Fish Stream Survey Report

(WALLY CREEK)

Camp PORT ALICE (CONE PEAK) Stream Name(ID) 103-80-003

Road# 5963 + 5965 Station# 19, 20, 29 Unit — RP# — —

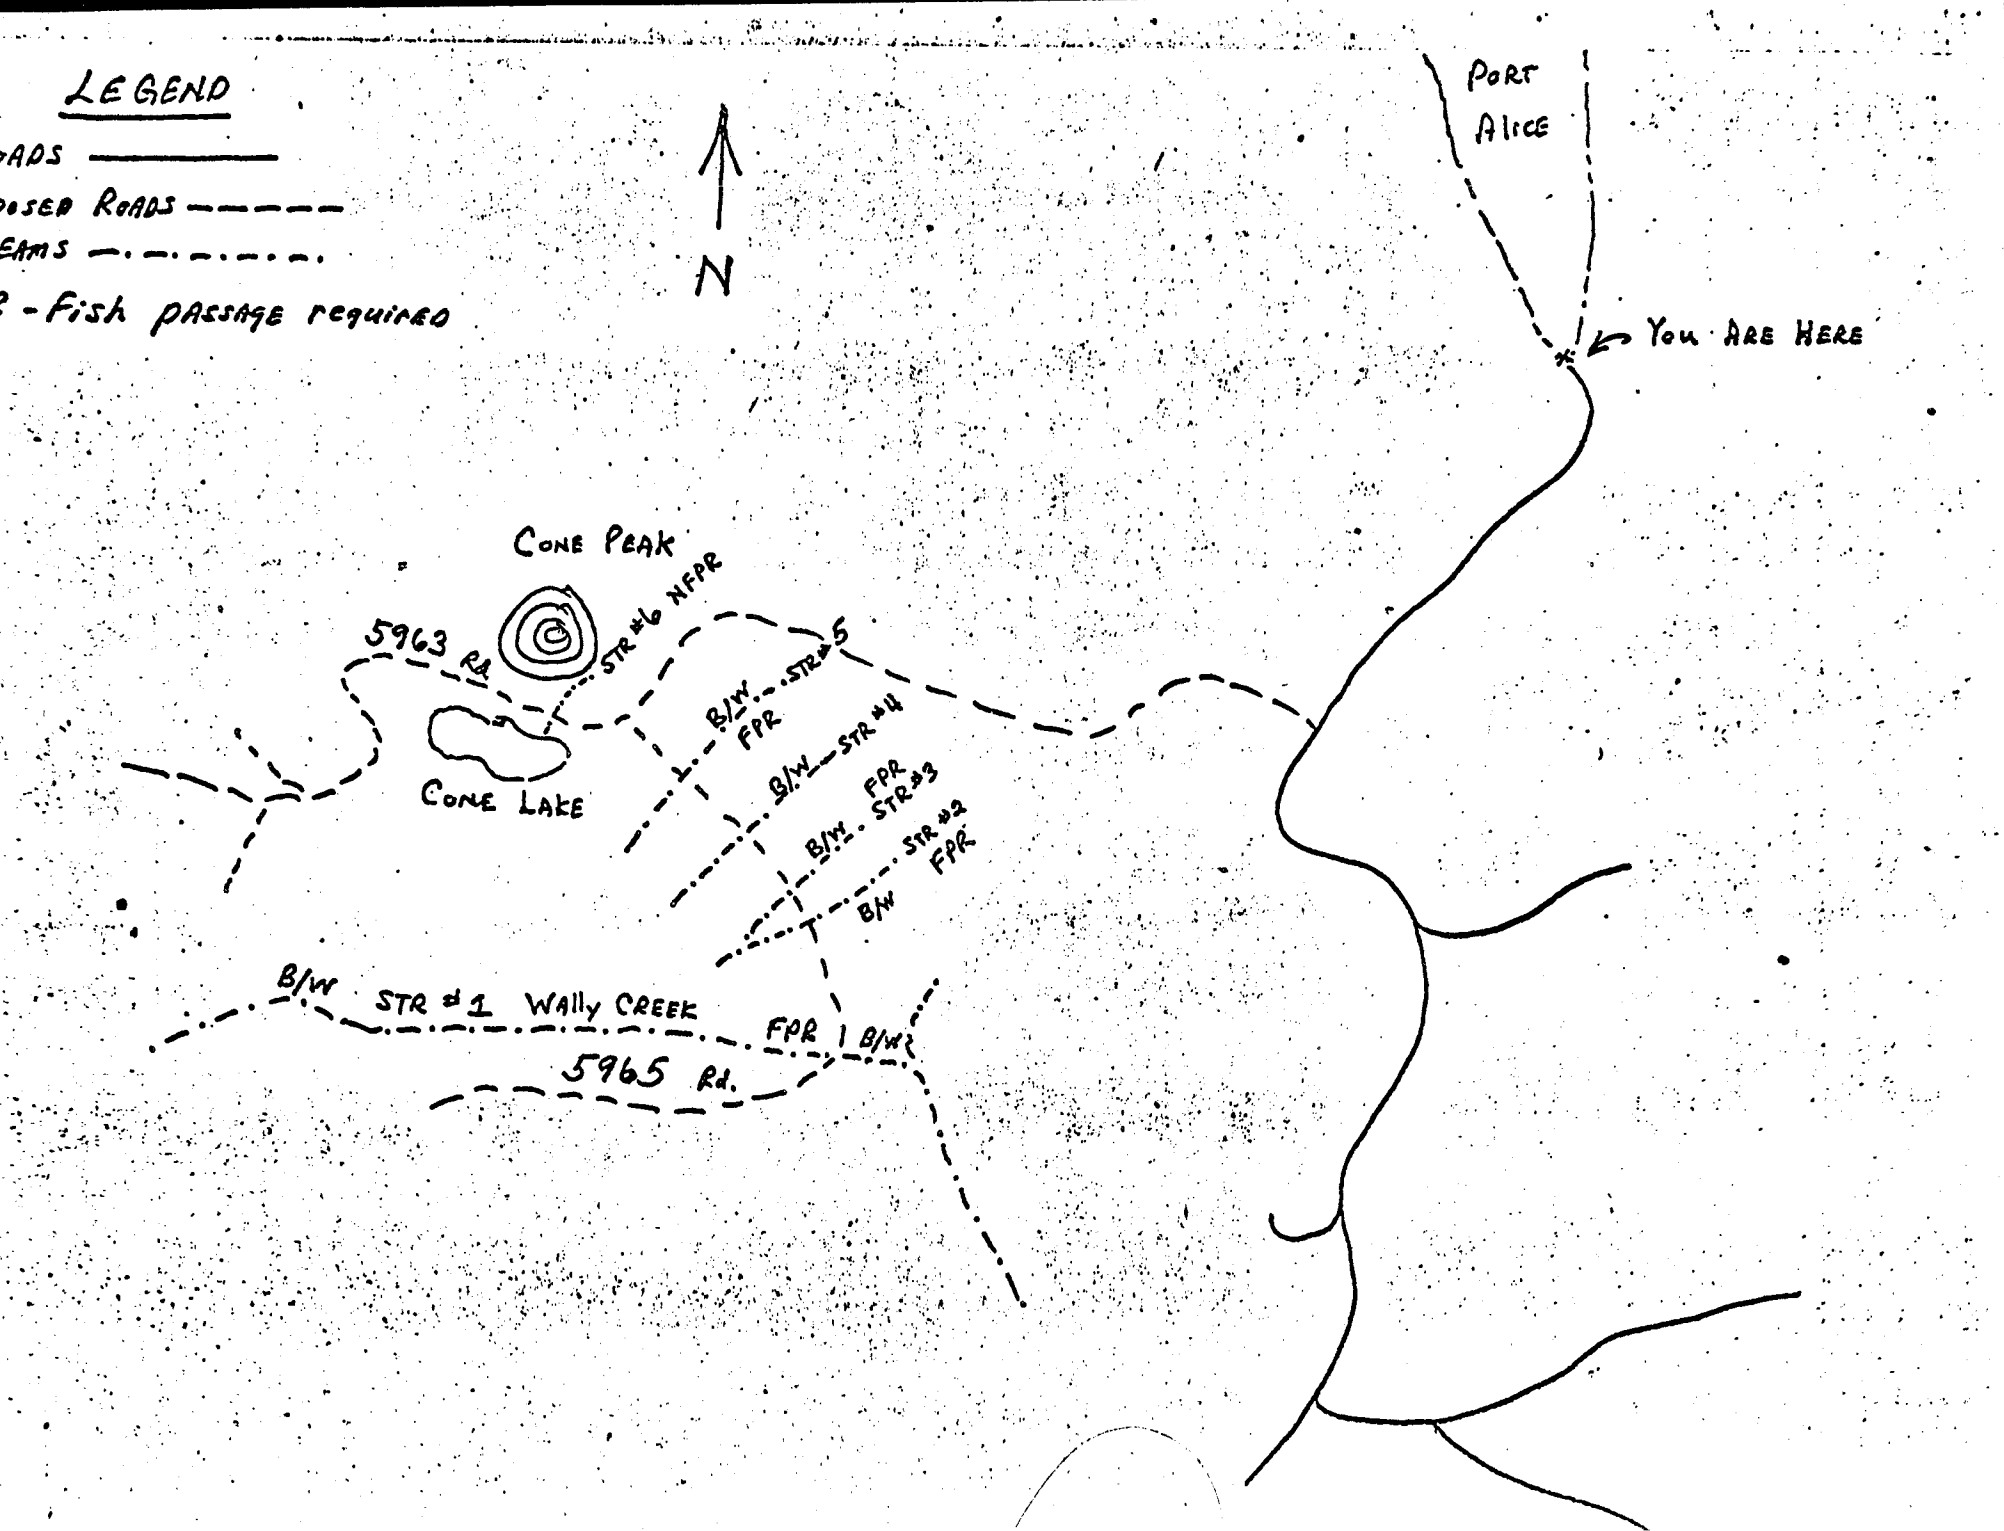
STREAM #1 - This stream is 15-20' wide, 6-12" deep with 3-4' pools and a substrate of rock, gravel + sand. Stream gradient is 1-2%. This is excellent salmon spawning habitat and several coho fry were shocked in location of proposed 5965 Rd. Stream was flagged B/W + tagged at proposed crossing. Fish passage is required.

STREAM #2 + 3 - These streams are located about 50' from each other and both are 2-3' wide, 6-12" deep and have a rock, gravel, sand + mud substrate. Gradient is about 1%. Coho were found in both and streams were flagged about 100' up + down stream from proposed road crossings and tagged at road/stream junction. Fish passage is required on both streams.

STREAM #4 - This stream is 3-4' wide, 6-12" deep and has a mud substrate with some rock. Gradient is about 1%. Coho were present in this area and stream was flagged B/W 100' up + down stream from proposed road crossing and tagged at road/stream junction. Fish passage is required

STREAM #5 - This STREAM is 3-5' wide, 6-12" deep with pools up to 18" AND A ROCK, gravel + SAND SUBSTRATE. GRADIENT is between 2-3%. Coho were present here AND STREAM WAS flagged B/W for 100' up + downstream AND TAGGED AT STREAM/ROAD junction. Fish passage is required.

STREAM #6 - This STREAM is 12-18" + 12-18" deep AND has a MUD SUBSTRATE. IT is fair to good salmon rearing habitat below the ROAD CROSSING AND STREAM WAS flagged downstream + TAGGED AT ROAD/STREAM junction. No fish passage is required.

Str #6 - This stream has coho present immediately below the proposed road crossing and if road is constructed at present location this habitat would be partially destroyed. Road should be moved backed away from Cone Lake so that no habitat will be destroyed. No fish passage is required. No debris or sediment should enter downstream and roadbuilding operations should follow the prescriptions outlined for streams 2, 3, 4, + 5.

RECOMMENDATIONS: STREAM #1 is A CATALOGUED SALMON STREAM AND fish passage is required. Road building operations should include directional falling, No limbing or bucking IN THE STREAM AND complete cleaning of all debris within 48 hours of deposit. Only one equipment crossing is allowed AND THE SUBSTRATE should be disturbed as little as possible. No sediment or siltation should be allowed to enter the STREAM AND operations should be timed so as to avoid SALMON SPAWNING periods. No P.I. NUMBER WAS available AT THE time of this survey.

STREAM #2, 3, 4 + 5 - These are all coho rearing streams and all require fish passage. Roadbuilding operations should include directional falling, no limbing or bucking in the stream and complete cleanup of all debris within 48 hours of deposit. Only one equipment crossing is allowed.
